Title-Sujet Boundary Swing Bridge Replacement for Trent Severn Waterway National Historic Site		
Solicitation No. - No. de l'invitation 5P468-22-0092/A		Date: August 25, 2022
GETS Reference No. – No de référence de SEAG PW-22-01003050		Client Ref. No. – No. de réf du client. RPA 344
Solicitation Closes – L'invitation prend fin :		
at – à 2:00 PM	on – le Sept 13, 2022	Time Zone - Fuseau horaire HAE - EDT
F.O.B. - F.A.B. Plant-Usine: <input type="checkbox"/> Destination: <input checked="" type="checkbox"/> Other-Autre: <input type="checkbox"/>		
Address Inquiries to: - Adresser toute demande de renseignements à : Sheldon Lalonde sheldon.lalonde@pc.gc.ca		
Telephone No. - No de téléphone 343-585-3836		Fax No. – No de FAX: 1-855-983-1808
Destination of Goods, Services, and Construction: Destinations des biens, services et construction :		
See Herein – Voir aux présentes

AMENDMENT #4

Product Number: 6PESAUS14-18G-V

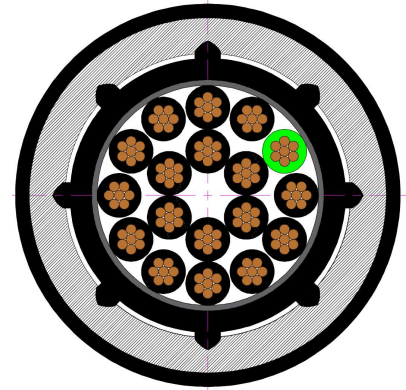
8) Regarding the detail of a submarine cable on Drawing C5 there is only a vague description in the specification. Individual cables are specified on the cable overview charts but these are for individual cables only. These cables specified cannot be constructed within the submarine cable as typically a submarine cable will only include a set number of gauge wires varying in size depending on what they control or power. Also if power and control wires are to be separate cable assemblies this will also have to be taken into account. Please indicate the contents of the submarine cable(s) for example 20 - #14, 8 - #12, 10 - #10, #16 – 2 pair Belden, etc.

The voltage levels in the cables are 240V/120V; they can be run side by each. The part numbers listed in the tables provide an indication of the makeup of the cable. For the submarine cables the numbering is as follows.

C59 - 6PES AUS14-30C-V / 600V SIA POWER CABLE is a 14AWG, 30 conductor cable
C94 - T6XAAUS12-3C-BFT4-HL / Conductor: Bare 7 stranded annealed is a 12AWG, 3 conductor cable.
C102 - 6PES AUS14-18C-V / 600V SIA POWER CABLE is a 14AWG, 18 conductor cable

Some or all of these and other cables will be special order. See attached product data sheets.
